Access Compliance Report

Public Rights-of-Way

(Curb Ramps)

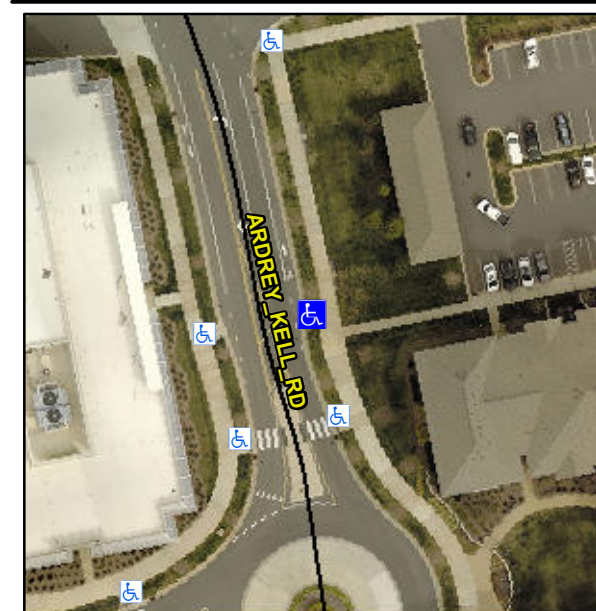
Intersection ID: 10019947	Main Street: ARDREY_KELL_RD	Cross Street: N/A	Location: NE
ADA ID: BDBFBE84D097	Ramp Type: Perp	Initial Pass/Fail: Fail	Overall Compliance: No
Severity Score: 12.5			
Codes/Mitigation Info/Possible Solution		Field Measurements/Component Compliance

R304.2.2

Compliance	Description	Data	Compliance	Description	Data
N/A	Ramp Length (in)	96.0	No	Ramp Slope (%)	8.5
Yes	Ramp Width (in)	73.0	Yes	Ramp XSlope (%)	0.1
N/A	Flare Type LT	N/A	N/A	Flare Type RT	N/A
N/A	Flare Slope LT (%)	N/A	N/A	Flare Slope RT (%)	N/A
N/A	Flare Traversable LT?	N/A	N/A	Flare Traversable RT?	N/A
N/A	Landing Length (in)	N/A	N/A	DWS Provided?	N/A
N/A	Landing Width (in)	N/A	N/A	DWS Contrast?	N/A
N/A	Landing Slope (%)	N/A	N/A	DWS Length (in)	N/A
N/A	Landing X Slope (%)	N/A	N/A	DWS Full Width?	N/A
N/A	Landing Curb? (Y/N)	N/A	N/A	DWS Offset (in)	N/A
N/A	Shared Landing?	N/A			
N/A	Gutter Ponding?	N/A	N/A	Gutter Slope (%)	N/A
N/A	Gutter Lip Ht (in)	N/A	N/A	Gutter X Slope (%)	N/A
N/A	Painted X Walk1?	No	N/A	Painted X Walk2?	N/A
	X Walk 1 Direction	To NW		X Walk 2 Direction	N/A
N/A	X Walk 1 Width (in)	N/A	N/A	X Walk 2 Width (in)	N/A
	X Walk 1 Slope (%)	2.6		X Walk 2 Slope (%)	N/A
	X Walk 1 X Slope (%)	0.7		X Walk 2 X Slope (%)	N/A

Remove & Replace Entire Ramp.
